Hurricane Planning Commission Meeting Agenda

October 23, 2025
6:00 PM

Agenda Date:	10/23/2025 - Planning Commission
Application Number:	AFP25-11
Type of Application:	Amended Final Plat
Action Type:	Administrative
Applicant:	Teresa Peters
Agent:	Cody Arnoldson
Request:	Approval of an Amended Final Plat.
Location:	3723 W 2800 S
Zoning:	Single Family Residential R1-10
General Plan Map:	Single Family
Recommendation:	Approve subject to staff and JUC comments.
Report Prepared by:	Fred Resch III

Agenda Date:	10/23/2025 - Planning Commission
Application Number:	PSP25-21
Type of Application:	Preliminary Site Plan
Action Type:	Administrative
Applicant:	The Hollows LLC
Agent:	Logan Blake
Request:	Preliminary Site Plan Approval
Location:	2950 S Sand Hollow Road
Zoning:	R1-8 (PDO) (designated Neighborhood Commercial)
General Plan Map:	Planned Community
Recommendation:	Approve subject to staff and JUC comments.
Report Prepared by:	Fred Resch III

CITY OF HURRICANE
SKY MOUNTAIN SUBSTATION
FENCE
PLAN VIEW

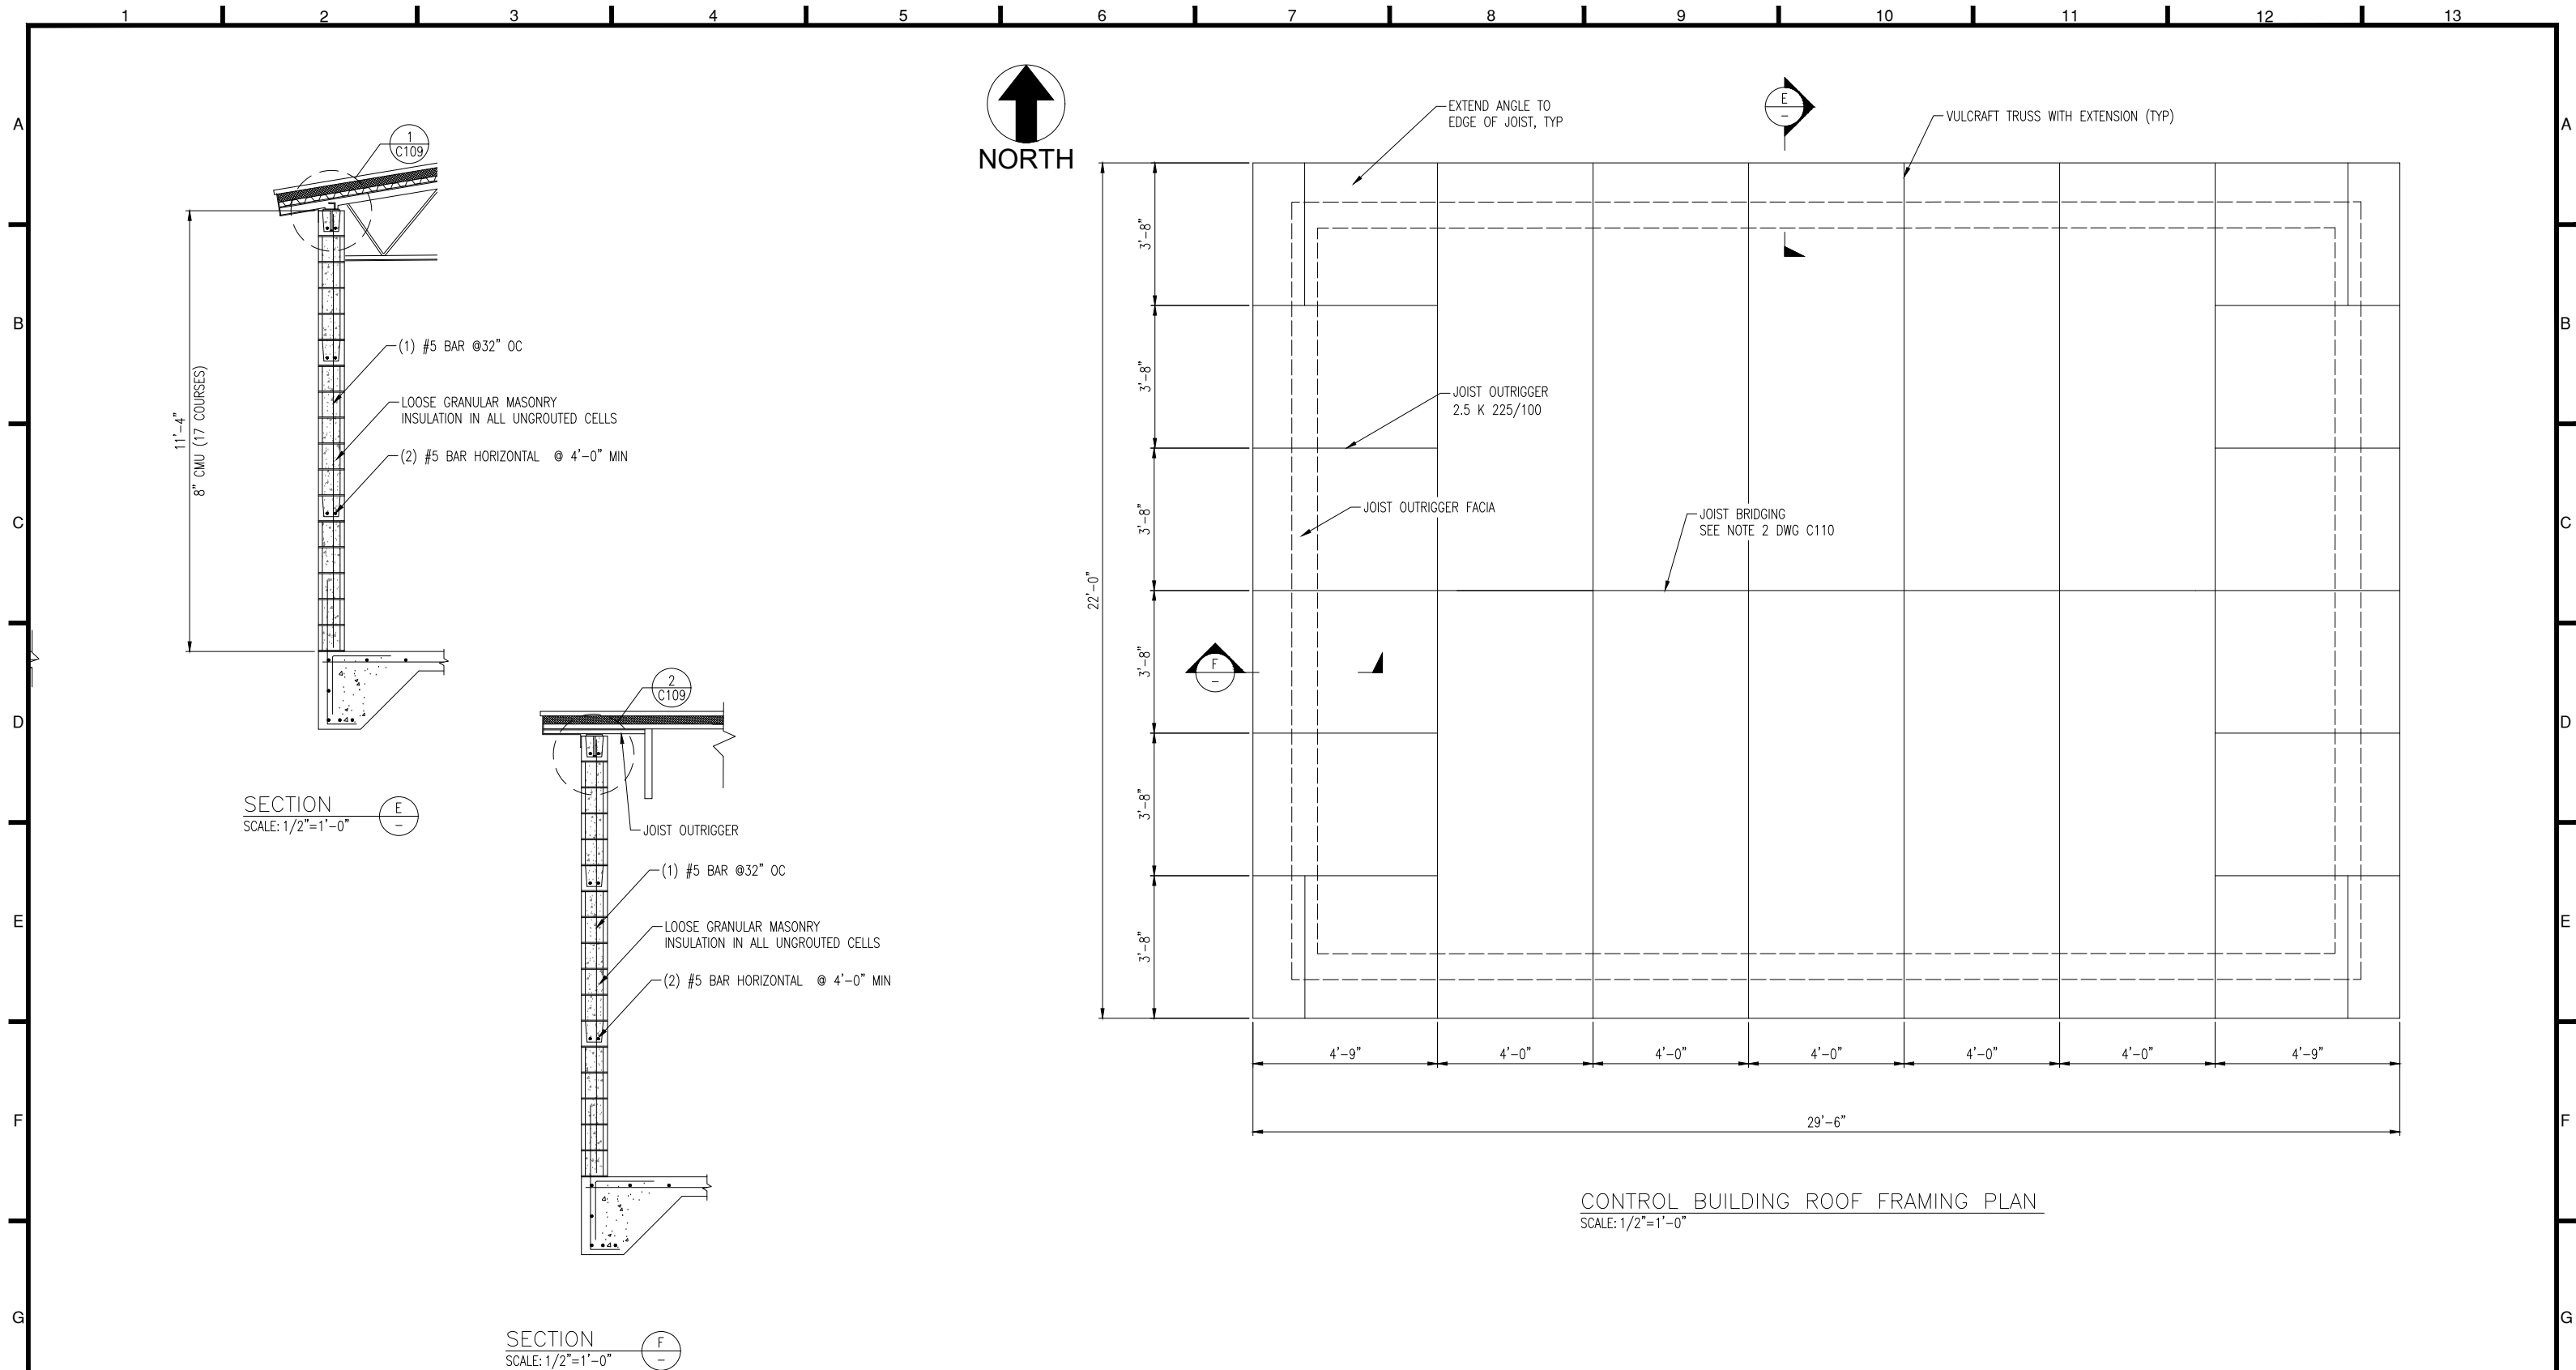
1. Hurricane City Code (HCC) requires that a substation shall provide fencing. HCC 10-45-4 (B) states,

“Fencing: The perimeter of the public utility substation site shall be fenced if necessary to provide public safety or protect utility equipment.”

Since this is a public utility facility, these standards do not apply.

3. Sight Obstruction at Intersections: The wall is set back sufficiently from the corner of 600 N and the future road to the west to maintain proper sight distances.

Recommendation: Staff recommends approval subject to staff comments.

**DESERT SANDS
GARAGE CONDOS (AREA E)**
4640 WEST DIXIE SPRINGS DR., HURRICANE, UTAH
PRELIMINARY SITE PLAN

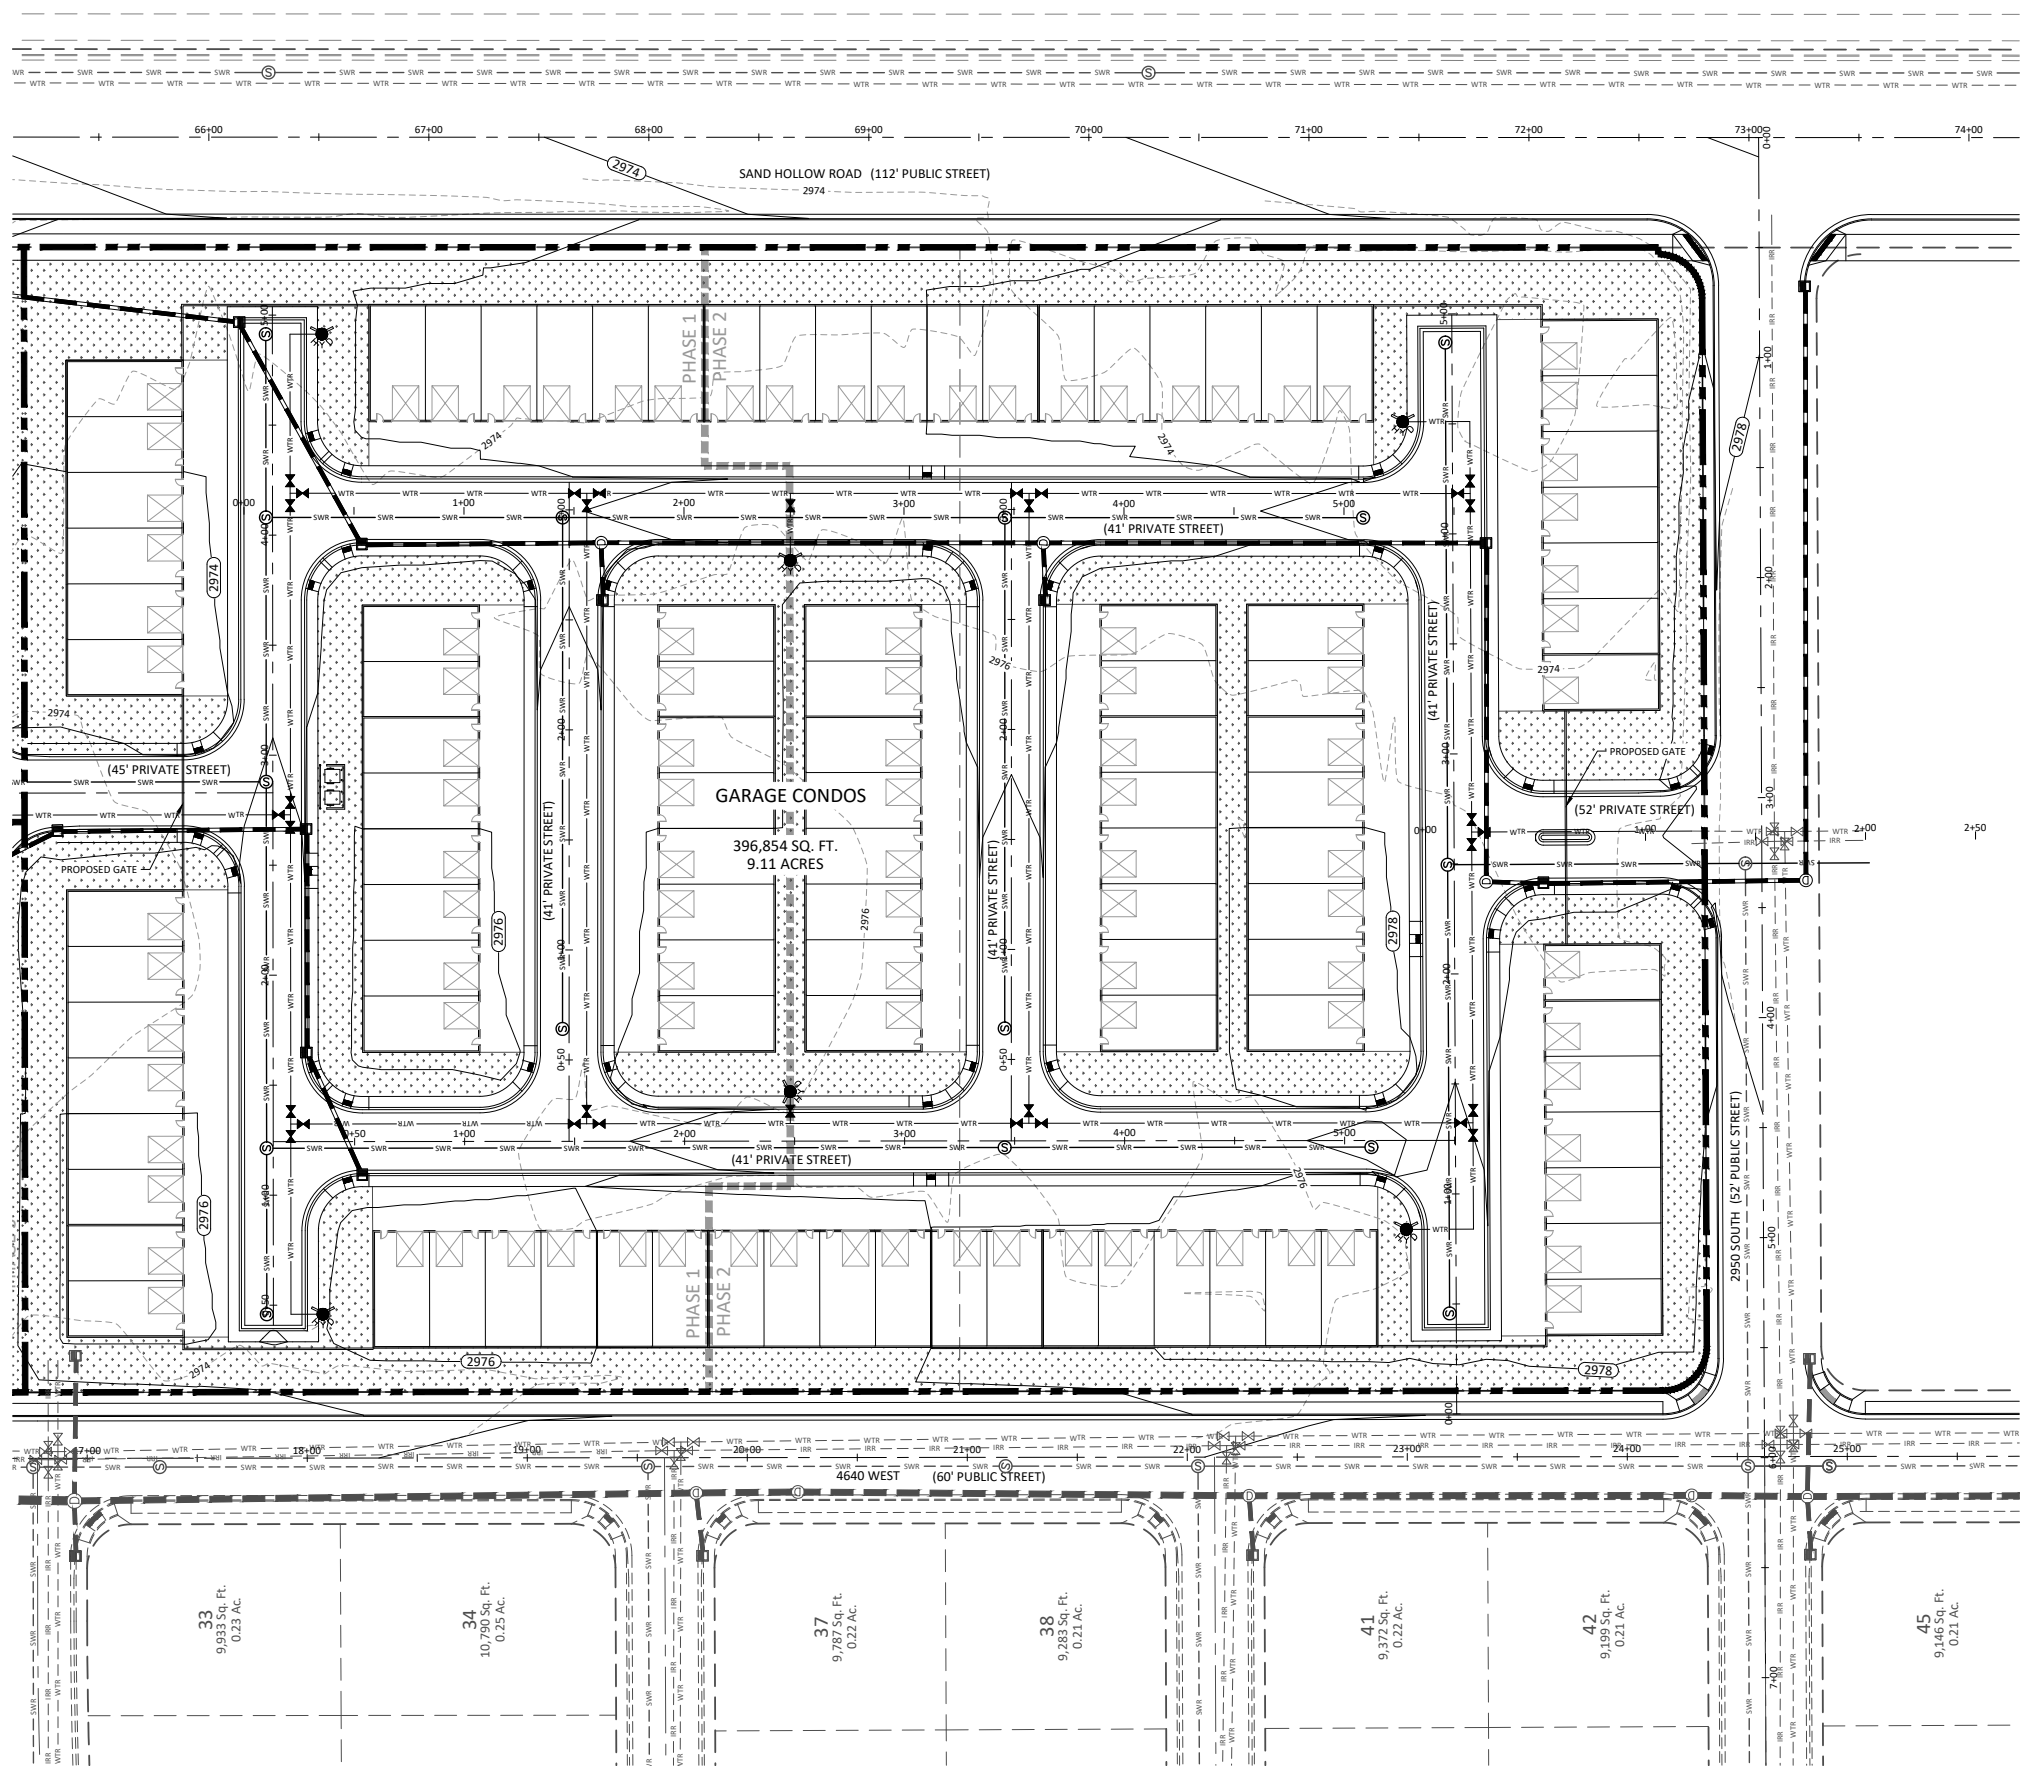
- 1. Public Works:** Look at access to 4640 W.
- 2. Fire:** Approved.
- 3. Sewer:** No comment.
- 4. Water:** Pipe to be ductile iron pipe. Water line needs to be looped.

- 5. Power:** Dixie Power area. Looks good.
- 6. Streets:** No comment.
- 7. Gas:** Okay
- 8. Infowest:** No comment.
- 9. Engineering:** Sand Hollow Road is an existing 90' public street. A road dedication to make it 112' wide has been distributed for owners' signatures. Recording said dedication must be coordinated with this project (HCC 10-39-11(A)(3)). A large diameter drainage alignment is depicted along Sand Hollow Road on Hurricane City's Storm Drain Master Plan. The project's drainage study must provide commentary on this (item 5, pg. 4-1, Hurricane City's Drainage Manual/HCS 3.4.1). Access to the units can be provided via driveways instead of streets (see HCC 10-34-8(B&C)). It appears this development would benefit from calling their accesses driveways because HCS 3.2.4 specifies private and public streets must be held to the same standard (e.g. sidewalks on both sides). Two sidewalks feel excessive for this type of development. Engineering has highlighted sidewalks worth keeping and suggests a new pedestrian connection to benefit the greater neighborhood (see comments for Desert Sands Commercial's preliminary site plan). This site is dependent on infrastructure provided by the Desert Sands Commercial site. Namely: water loop, sewer outlet, and storm drain outlet. Water mains on private property must be ductile iron (HCS 4.4.1.4(C)).

- 1. Land Use:** The proposed use of warehouse, self storage is not currently approved in Neighborhood Commercial, but was approved as part of the PDO approval for Desert Sands as a potential use in the Neighborhood Commercial portions of the development. No residential use is permitted within these zones; therefore, residential use of the units is not permitted. The

2. **Parking Requirement:** Per Hurricane City Code (HCC) section 10-34-10,

There does not appear to be any office space depicted on the site plan, regardless each unit is depicted with driveway space and garage space.

3. **Landscape:** Hurricane City Code (HCC) requires that a landscape buffer of 10' wide shall front each right-of-way. A complete landscape plan will be required with the final site plan in order to verify the requirements of the code section cited below; the necessary space for landscaping appears to be depicted on the preliminary site plan.

4. As stated in Engineering comments above (JUC #9) private streets are discouraged within Hurricane City ordinances and standards but where this is a commercial development, private “drive-aisles” make sense for the development.

Recommendation: The Planning Commission should review this application based on standards in the Hurricane City Code. Staff recommends approval of the preliminary site plan subject to JUC and staff comments.
